HARTZELL PROPELLER INC.
SERVICE LETTER

HM-SL-002

Propeller - Hub Clamping Bolt Inspection

**Hex Head Bolt
Figure 1**

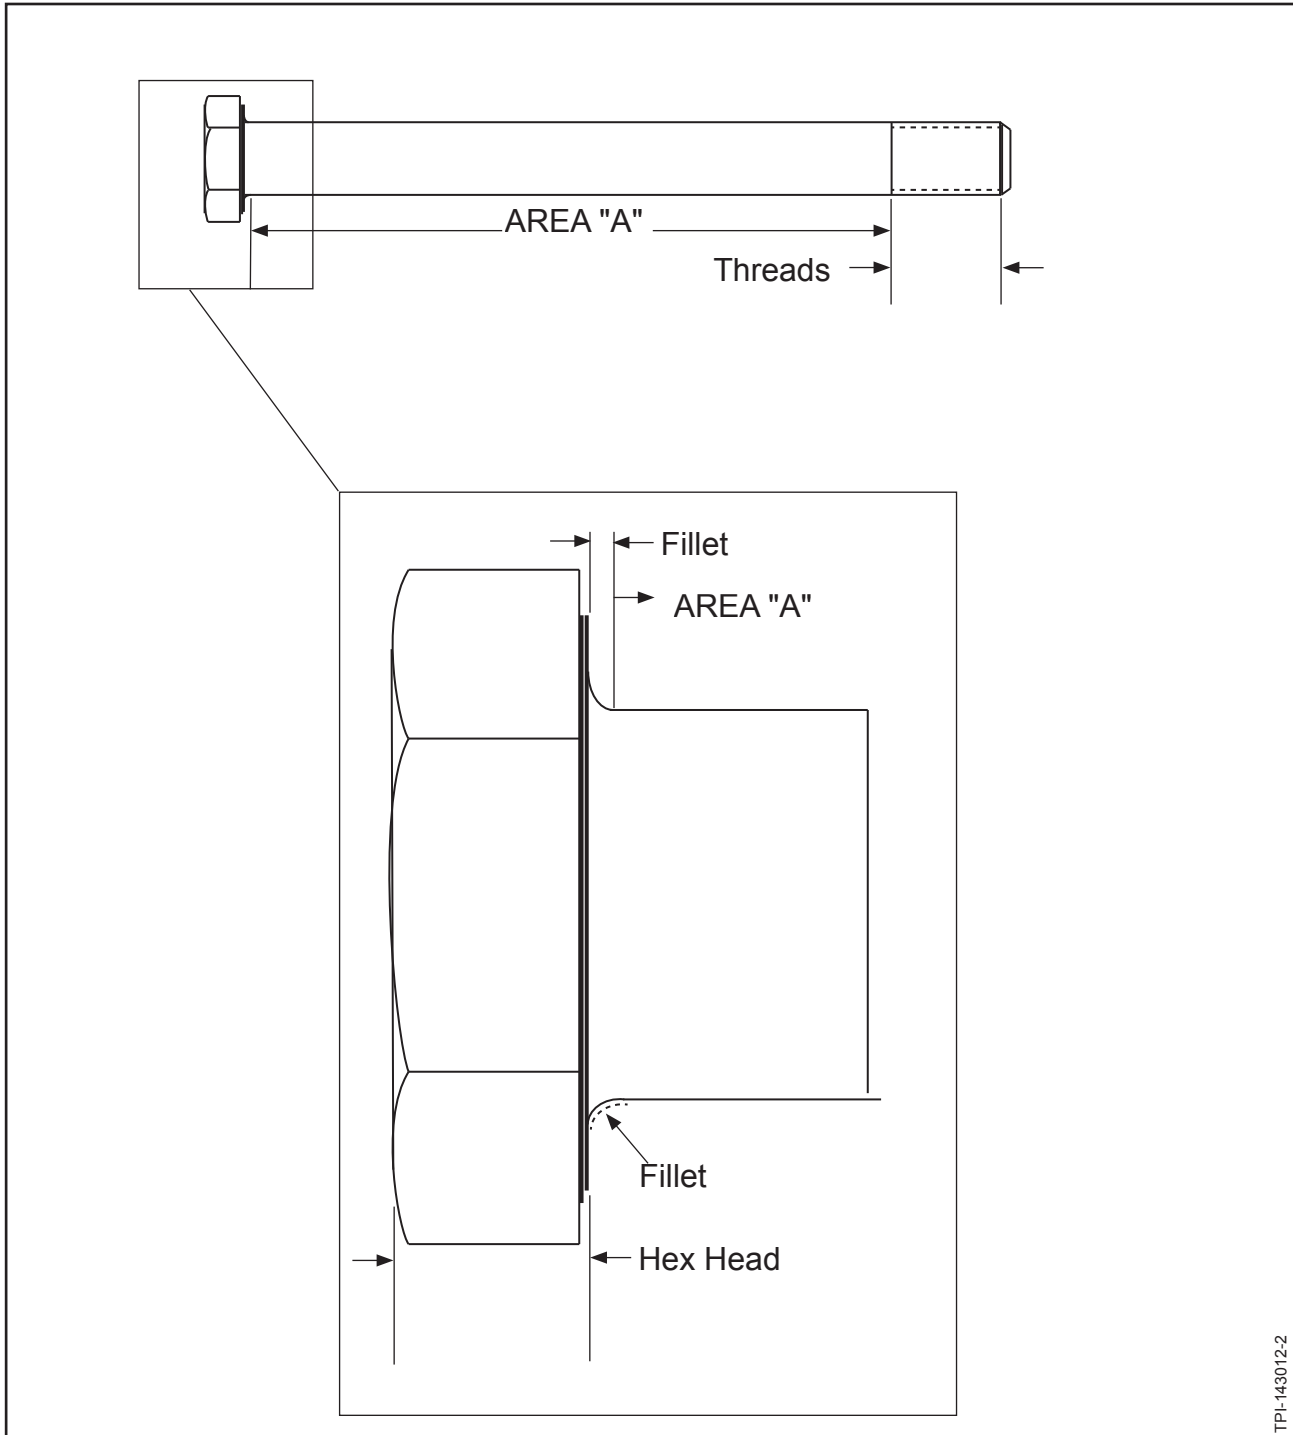
Inspect	Serviceable Limits	Corrective Action
<u>HEX HEAD BOLT</u>		
Refer to Figure 1.		
(1) Visually examine the hex head bolt for corrosion and pitting.	Corrosion is not permitted. The maximum permitted depth of pitting is 0.002 inch (0.05 mm). No more that 5% of the total unthreaded surface may be pitted. The maximum permitted diameter of an individual pit is 0.032 inch (0.81 mm). Pitting is not permitted in the fillet between the hex head and the grip, area "A". Pitting must not affect the fit or function of the hex head bolt.	Corrosion may be removed using glass bead cleaning. Refer to the Cleaning chapter of Hartzell Propeller Inc. Standard Practices Manual 202A (61-01-02). If the pitting is greater than the permitted serviceable limits, replace the hex head bolt.

(2) Except for the threads, visually examine the hex head bolt for damage or scratches.	The maximum permitted depth of damage or a scratch is 0.002 inch (0.05 mm). Scratches or damage must not affect the fit or function of the hex head bolt. Pushed-up material is not permitted.	Pushed up material may be removed. If the depth of a scratch or damage is greater than the permitted serviceable limits or affects the fit or function of the bolt, replace the hex head bolt.

(3) Visually examine the hex head bolt for circumferential scoring caused by installation and removal.	Circumferential scoring that reduces the diameter of the hex head bolt is not permitted. The minimum permitted OD in Area A is 0.370 inch (9.40 mm).	If the scoring is greater than the permitted serviceable limits or the OD in Area A is less than the serviceable limits, replace the hex head bolt.

(4) Visually examine the wrenching surfaces of the head of the hex head bolt for metal movement caused by wrenching.	Limited damage from wrenching is permitted, but the hex head bolt must be able to be torqued and metal movement must not interfere with the installation of the hex head bolt or cause damage to the hub.	Remove metal movement with a file or equivalent. Only corners may be repaired. Refacing a complete surface is not permitted. If metal movement is greater than the permitted serviceable limits, replace the hex head bolt.

Inspect	Serviceable Limits	Corrective Action
<u>HEX HEAD BOLT, CONTINUED</u>		
Refer to Figure 1.		
(5) Visually examine the threads of the hex head bolt for damage and pitting.	A maximum total accumulation of damage and pitting of 3/4 thread is permitted. Thread damage must not cause damage to the mating part. An A-2043-1 nut with the plastic locking element removed should be able to freely rotate by hand on the bolt threads. For the modification of the nut, refer to Figure 2.	Limited thread file repair is permitted, but must be considered as thread damage. If the damage and pitting is greater than the permitted serviceable limits, replace the hex head bolt.

(6) Magnetic particle inspect each bolt in accordance with the Magnetic Particle Inspection chapter of Hartzell Propeller Inc. Standard Practices Manual 202A (61-01-02). <u>NOTE:</u> It is not necessary to strip the cadmium plating from the hex head bolt before magnetic particle inspection.	A relevant indication is not permitted.	If there is a relevant indication, replace the hex head bolt.

(7) Visually examine the hex head bolt for cadmium plating coverage.	Cadmium plating must completely cover the bolt with the following exceptions: A few scratches and corners with cadmium plating missing, minor abrading of cadmium plating on the threads, or minor abrading of the cadmium plating on the hex head because of wrenching.	Cadmium replate and bake for a minimum of 23 hours within four hours after plating the hex head bolt in accordance with the Cadmium Replating chapter of Hartzell Propeller Inc. Standard Practices Manual 202A (61-01-02).
